MUNICIPAL OFFICE,

With reference to ~~their~~ ^{his} application, dated 3rd instant 191, with plans for the proposed addition of water on plot No. 36A Nos.

Survey Sheet A16, Markel Quarter,

SHOWING ADDITIONS TO PLOT No. 36. A SHEET A-16.

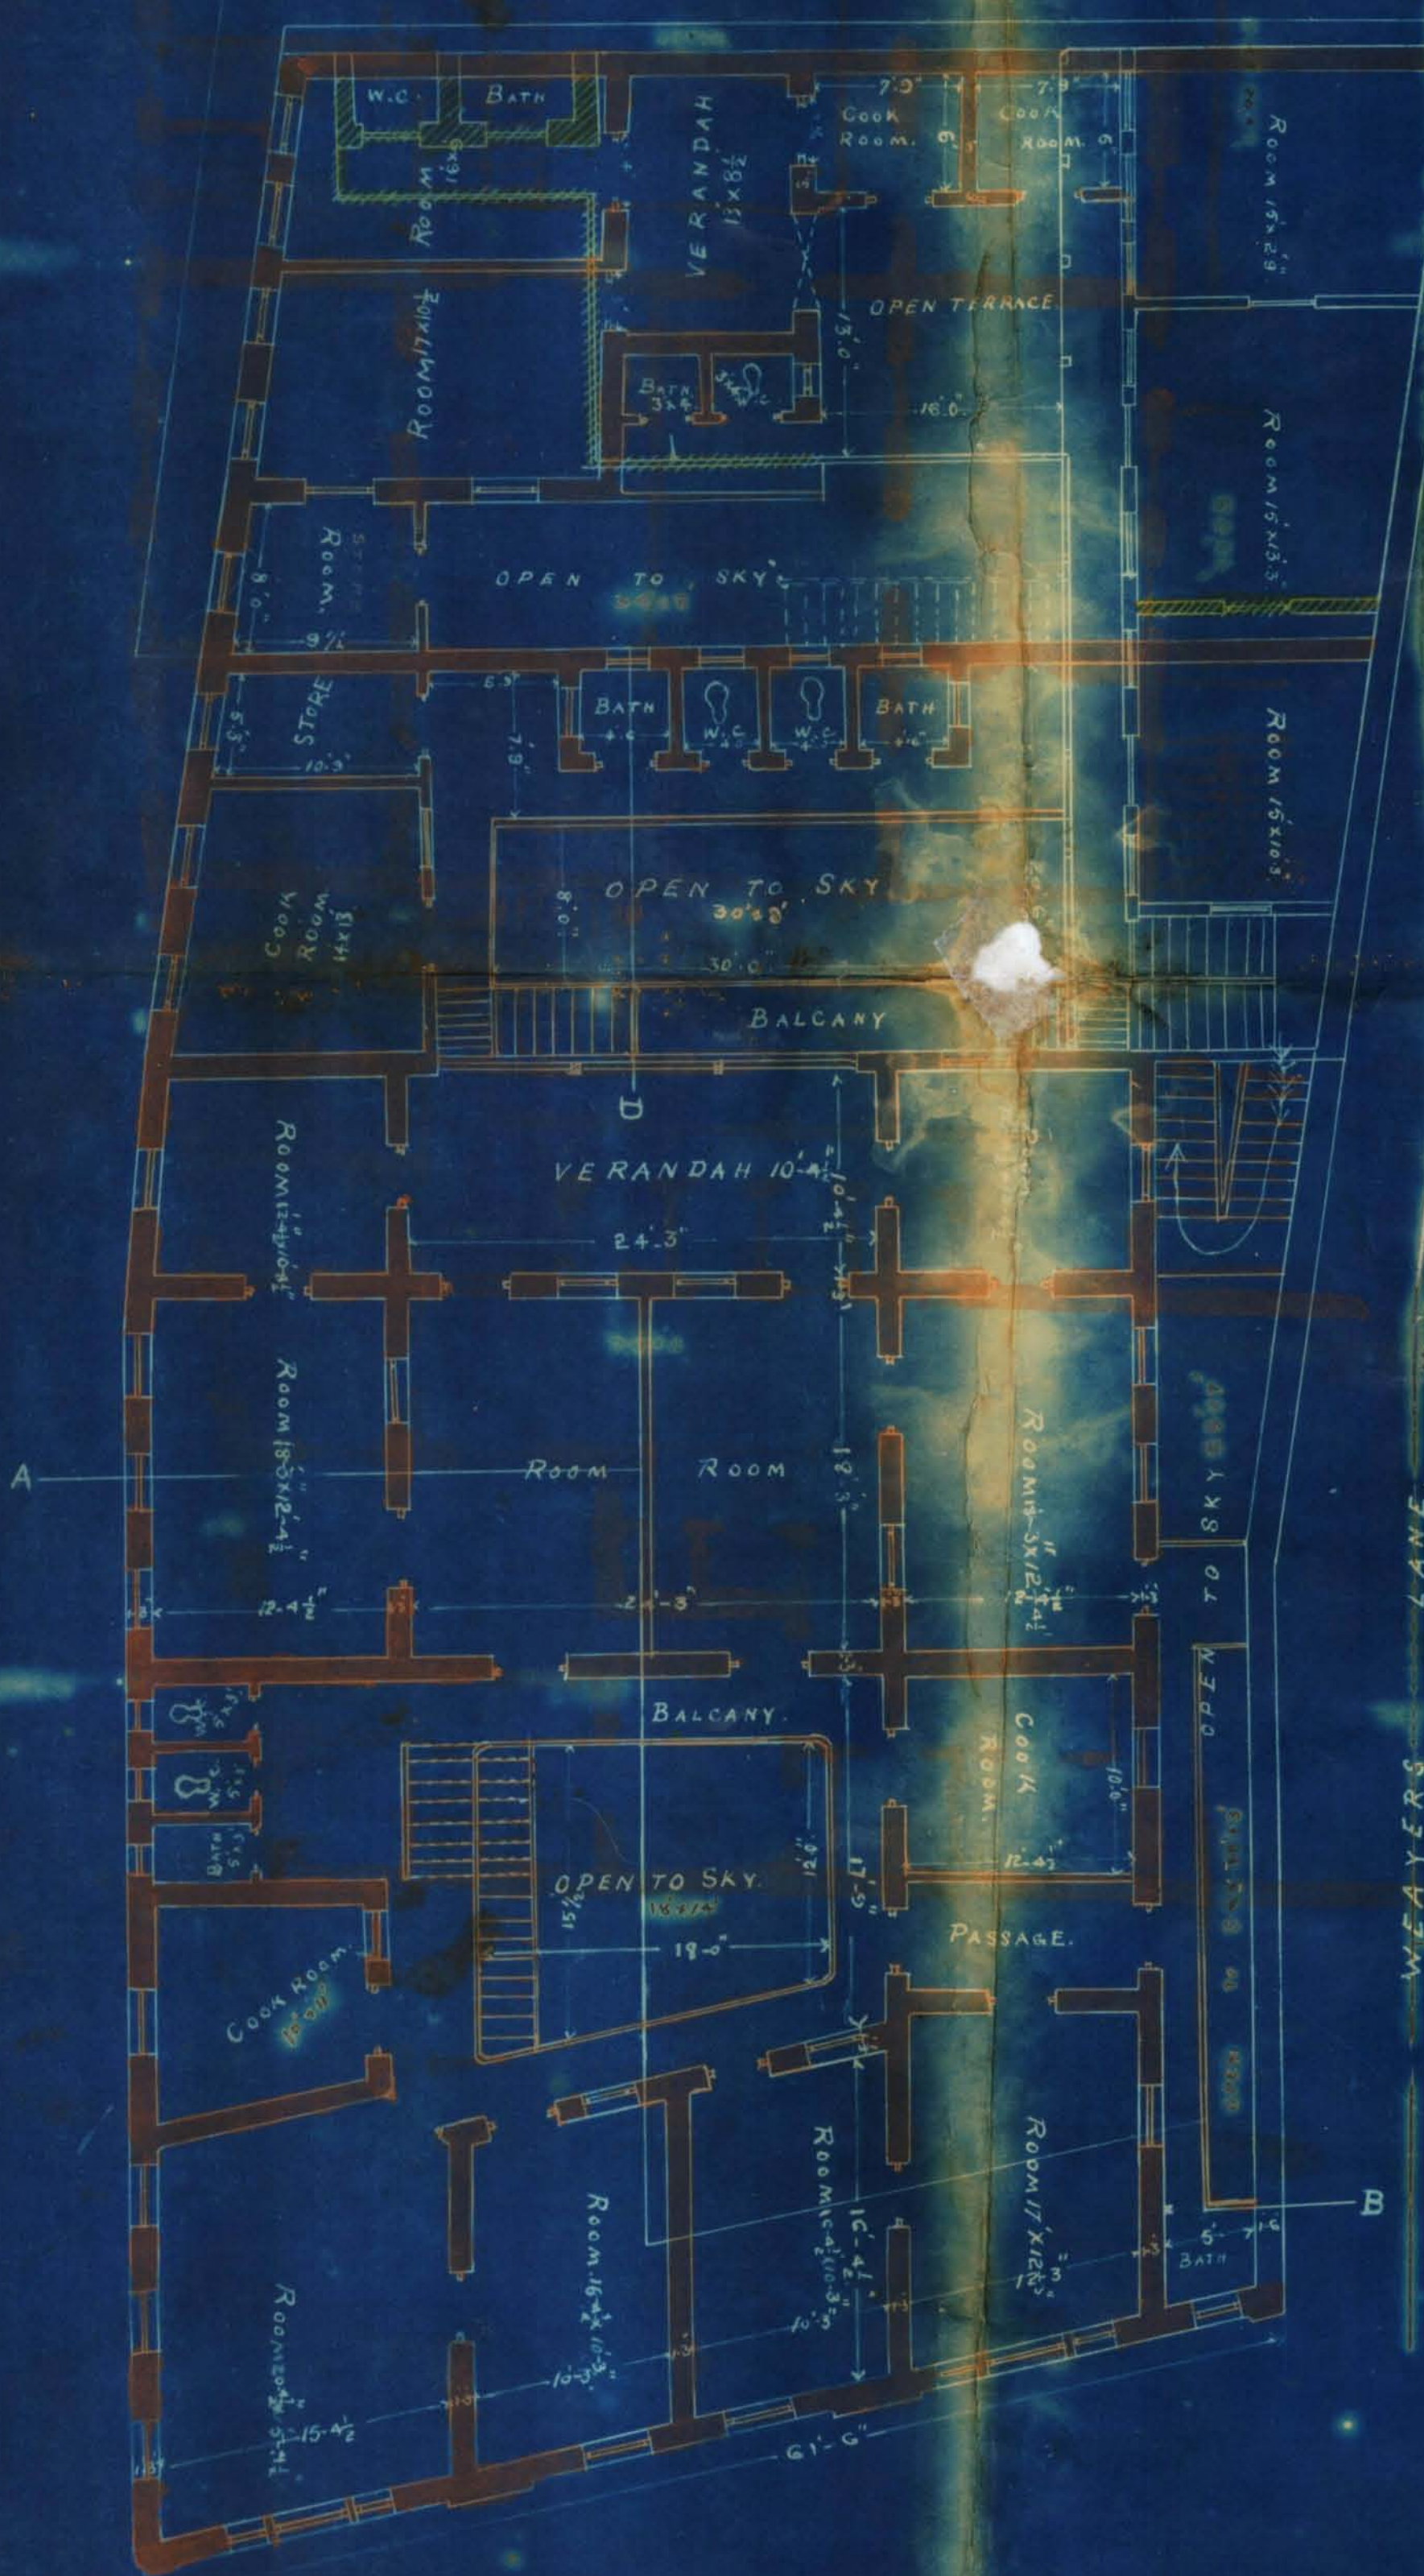
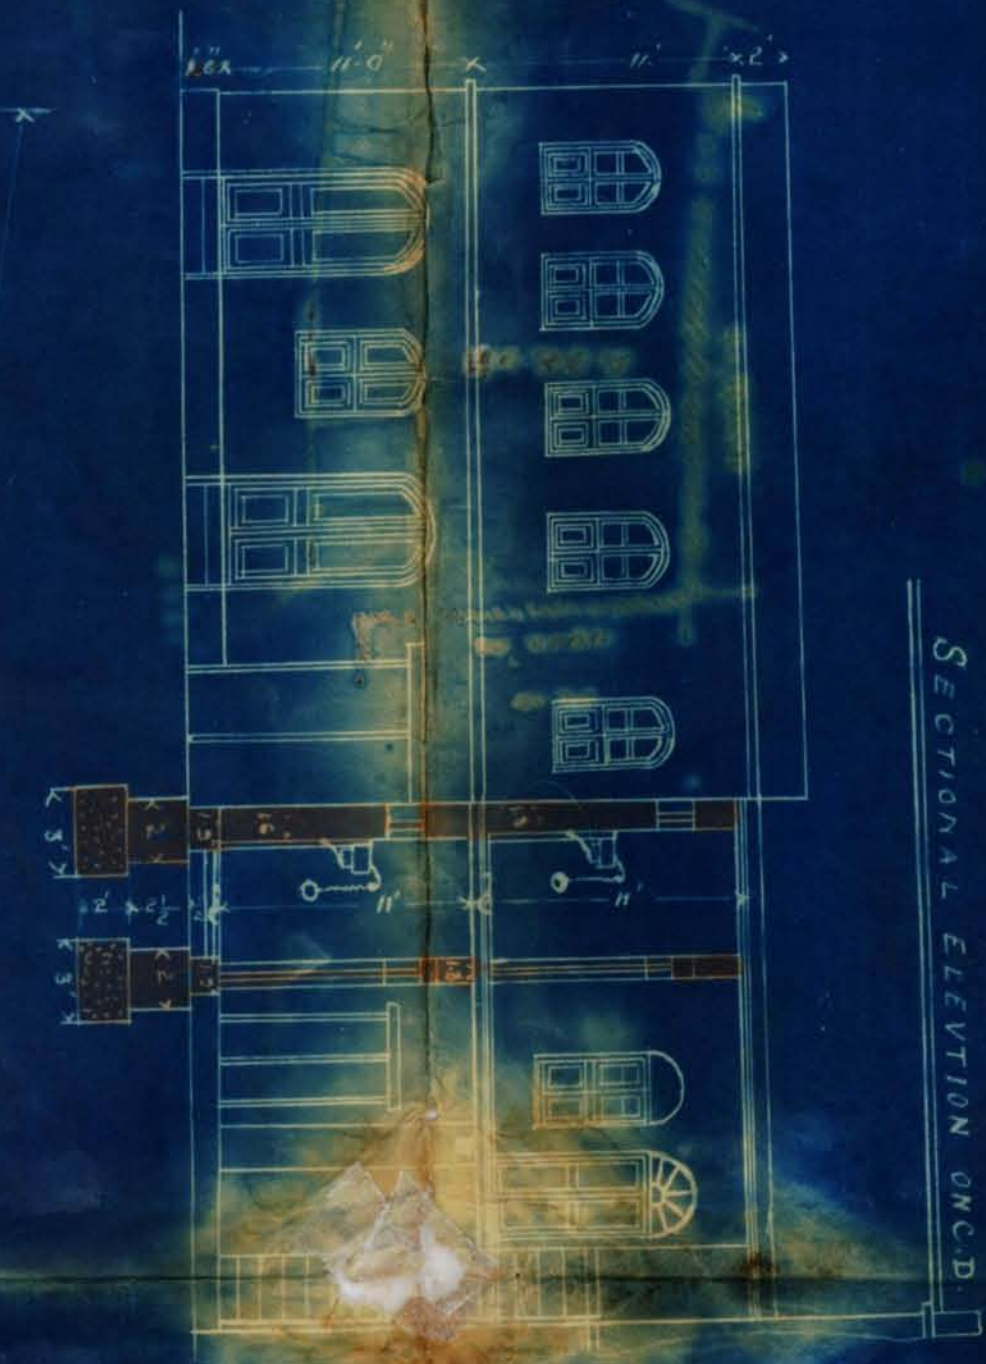
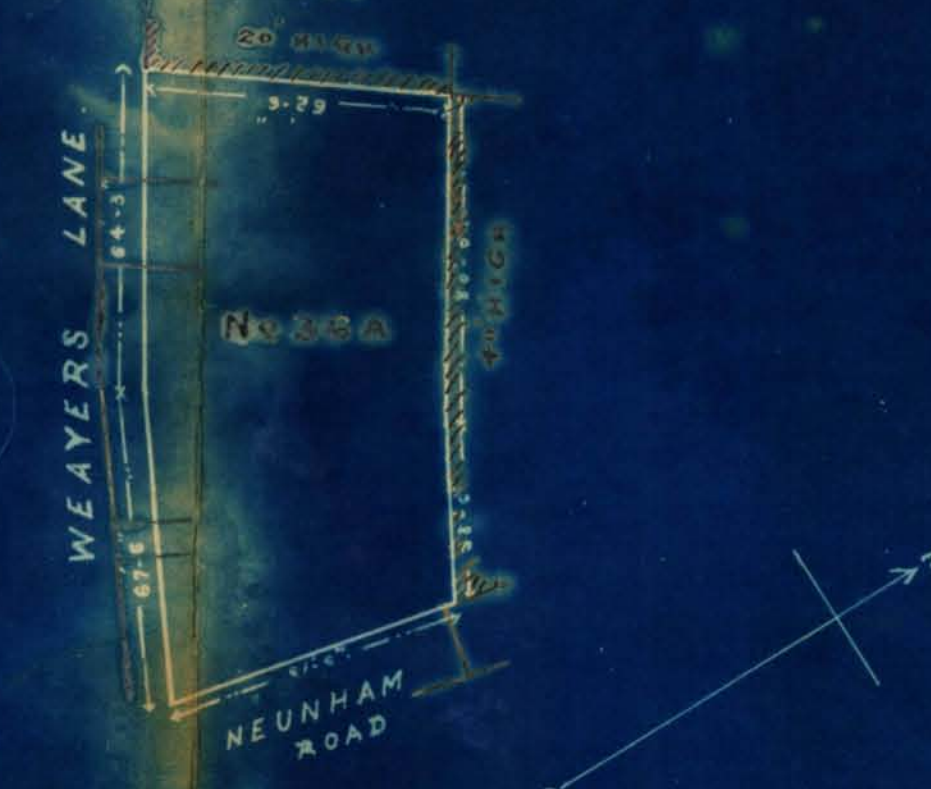
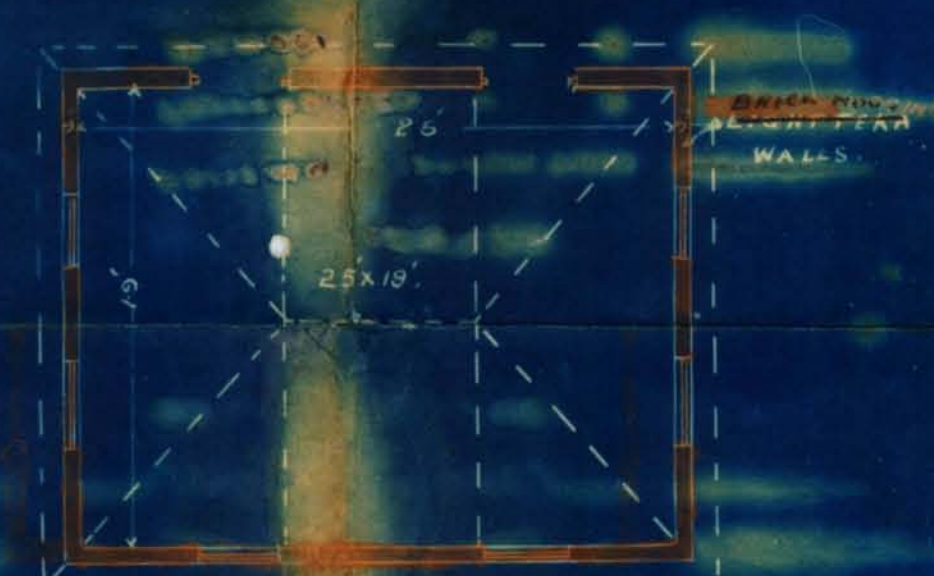
With reference to his application with plan received on 15th March 1920 for building on plot No. 36A, A-16 Market Quarter Mr. Mohanlal Tulsidas Sodah is informed the plot is being overcrowded with buildings and the internal rooms will be dark and unfit for human habitation. The narrow 3'-0" gulley must be removed from it. The central portion hatched in pencil must be kept open to sky.

The portions of plot coming under alignment must be shown as set back before the plan can be approved.

Some of the existing rooms are already dark & the proposed addition will make them worse & unfit for human habitation

Sir. With respect to this I beg to report a sweepers.
passage for cleansing the street
to the east of the plot is necessary (2) The hall.
the adjoining rooms
will be very badly ventilated. The position
of WC's right in the centre of the bldg is
most objectionable. The applicant is as it were
tries to overcrowd the plot. which should
not be allowed.

Remarks Sir, I beg to report that the plan as
submitted is over crowded the plot &
the it should be properly designed.
the Building surveyor's objections to
adhere to

Why does the L.S. say there is no alignment when the
Surveyor shows alignment on Map as done?
The plot is being overcrowded with building
& the internal rooms will be dark & unfit
for human habitation. The narrow 3' gully
cannot be allowed. The gallery must be removed
from it. The central portion hatched in pencil
must be kept open to sky.

With respect to the above Plan & S.C. I beg to report. The applicant has not as yet enlarged the open space to the east of the plot as required by our memo. The 3' gallery that was objected to has been widened to 5' + the gallery is deleted. Hence there is no objection. The 1st of 9th floor as proposed would not allow of lofts for which there should be 16' 6" clearance. Request orders.

The narrow 3' gallery has been removed. The portion of the plot coming under alignment which is very slight has been so shown on the site plan. On detained plan the wall along the Weaver Lane has already been shown in straight line.

As regards the central portion to be kept open to sky as shown hatched in pencil, I am to state that rough pencil design was shown to you and open space was left according to your instructions by demolishing the Verandah Walls and the Western Walls as shown hatched in green. Notwithstanding that, I have further increased the open area by removing gallery in front of the main hall, thus making the space open to sky 18'x18'. Besides this, further 3' open space on the east has now been kept by removing the 3' covered gallery as stated above. If the wall marked "W" in pencil is demolished, it will present great difficulty from Engineering point of view during construction. The new wall further down will be an independent wall, and as the adjacent walls are old, it will be difficult to joint the concrete and foundation masonry with the old walls, the bonding of the new work with the

old will be nominal. This will make the whole structure unsound. Under the circumstances I request that you will reconsider matter and allow the open spaces as now further increased as shown on the plan. They are not insufficient considering the proportion of open spaces left in recently constructed buildings in Karachi.
